## Rio Mesa High School Campus Security Fencing Project

### BID CLARIFICATION ADDENDUM #1

# ADDENDUM NUMBER ONE

**OUHSD RIO MESA HS SECURITY FENCING**  
545 Centra Ave  
Oxnard, CA 93036

##### ITEM NO. 1: NORTH FENCE SECTION DETAIL

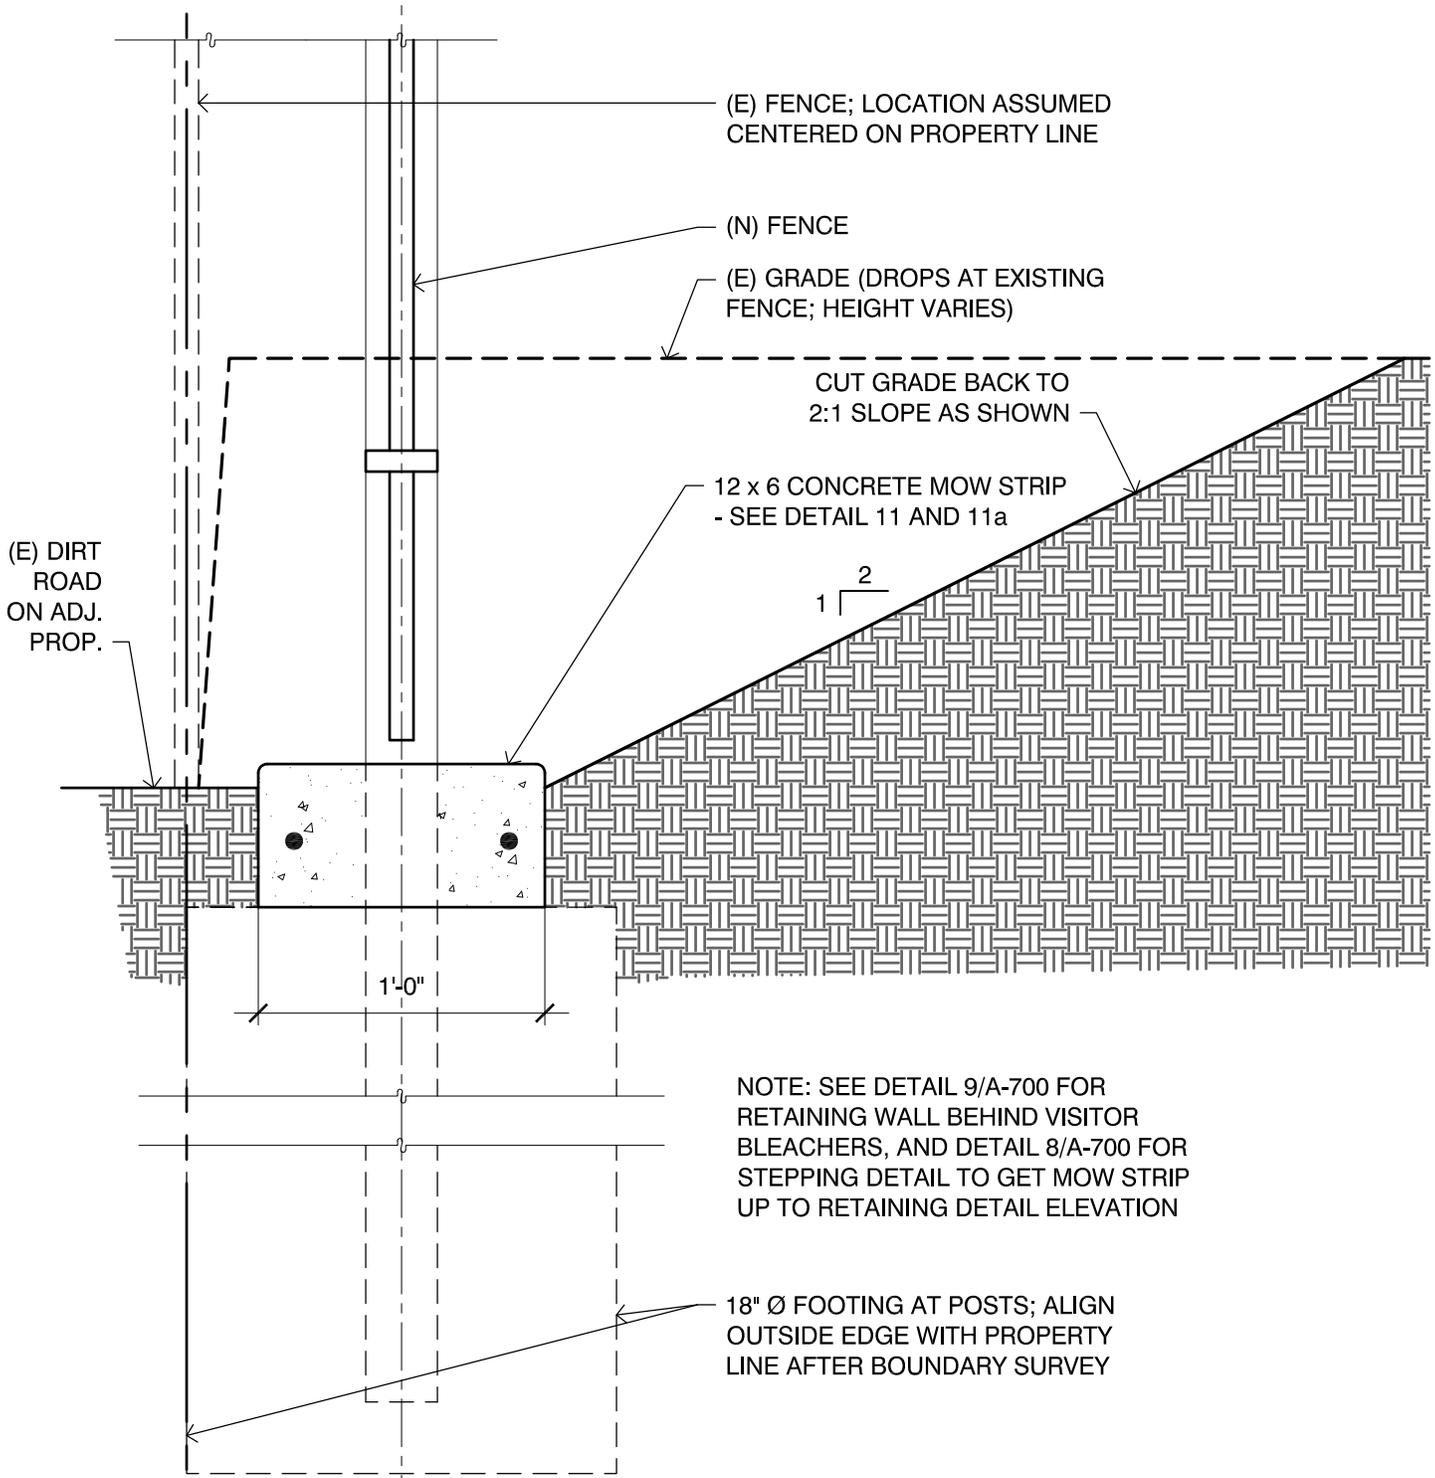
Please refer to attached drawing AR-01, which modifies the north fence installation. It is assumed that the existing north property line fence is within the OUHSD property and will be removed, and the new fence/mow curb aligned with the property line as shown in the detail on AR-01. The note at the north property line fence on sheet A-100 has also been revised accordingly.

Note: the new retaining wall behind the visitor bleachers will be aligned in a similar fashion, with the face of footing aligned with the property line.

18" Ø FOOTING AT POSTS; ALIGN OUTSIDE EDGE WITH PROPERTY LINE AFTER BOUNDARY SURVEY
